SUNDRY NOTICES AND REPORTS ON WELLS
Do not use this form for proposals to drill or to re-enter an abandoned well. Use Form 3160-3 (APD) for such proposals.

San Juan 31-6 Unit 212A

ConocoPhillips requests permission to P&A the subject well per the attached procedure, current and proposed wellbore schematics.

Re: Permanent Abandonment
Well: 212A San Juan 31-6 Unit

Proposed Schematic

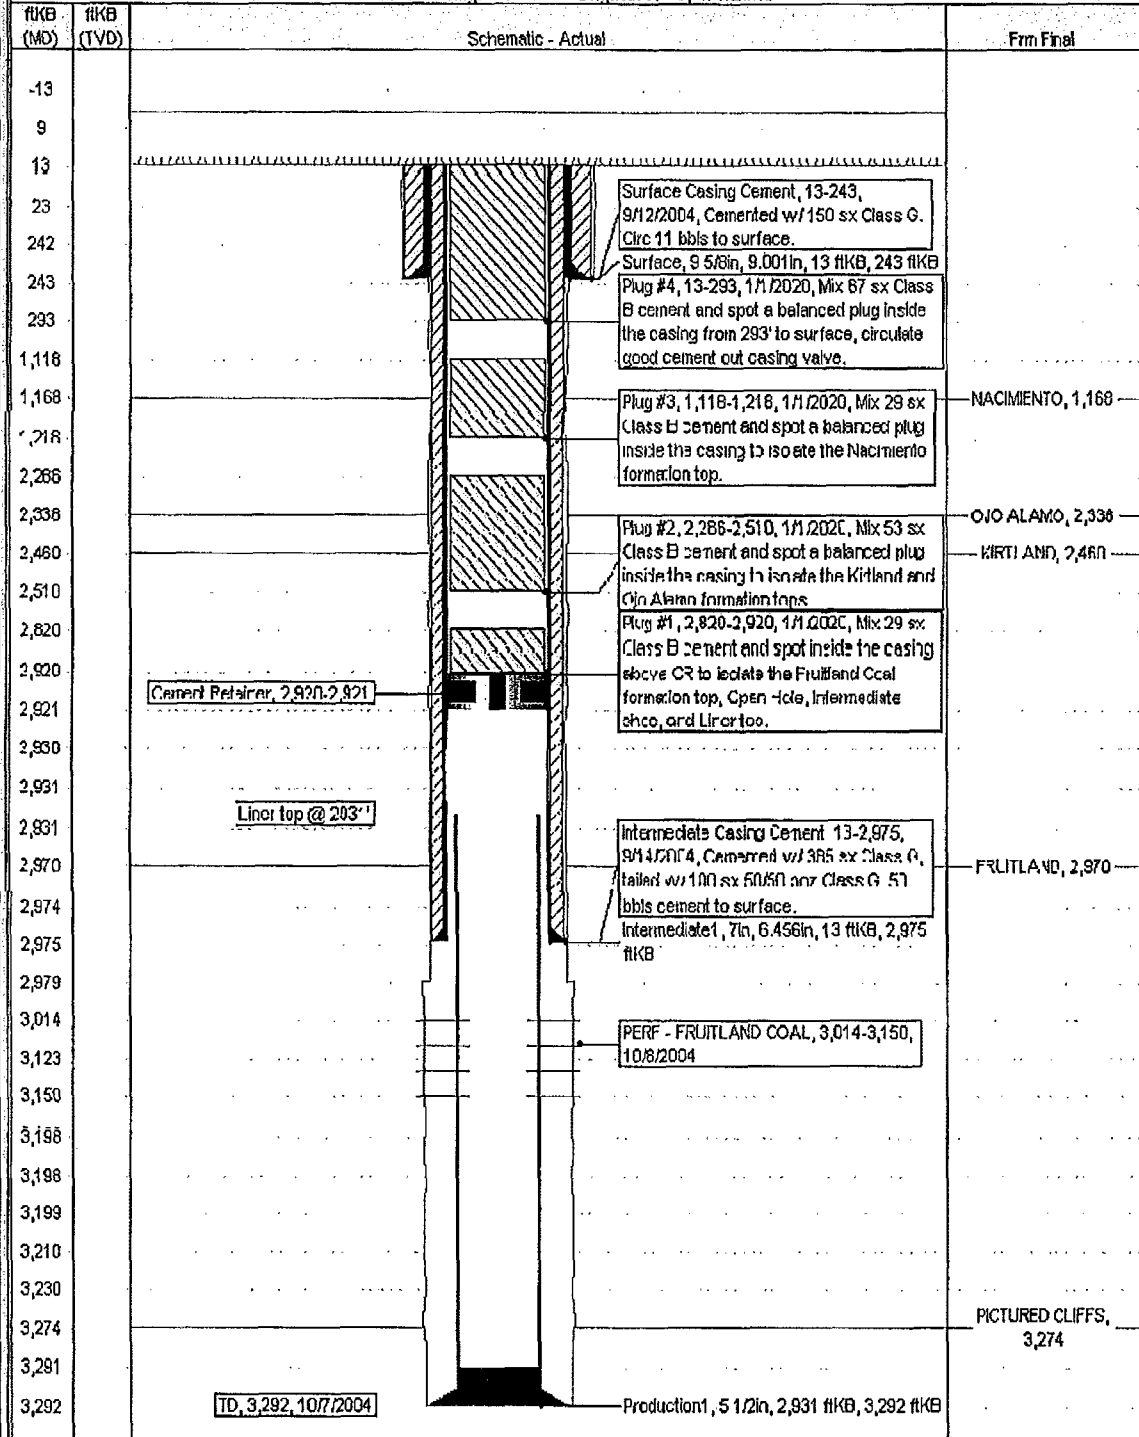
1. Plugging operations authorized are subject to the attached "General Requirements for Permanent Abandonment of Wells on Federal and Indian Lease."
2. Farmington Office is to be notified at least 24 hours before the plugging operations commence (505) 564-7750.
3. The following modifications to your plugging program are to be made:
 - a) Place the Kirtland/Ojo Alamo plug from 2480' - 2207'.
 - b) Place the Nacimiento plug from 1189' - 1089'.

2480 2207

1189 1089
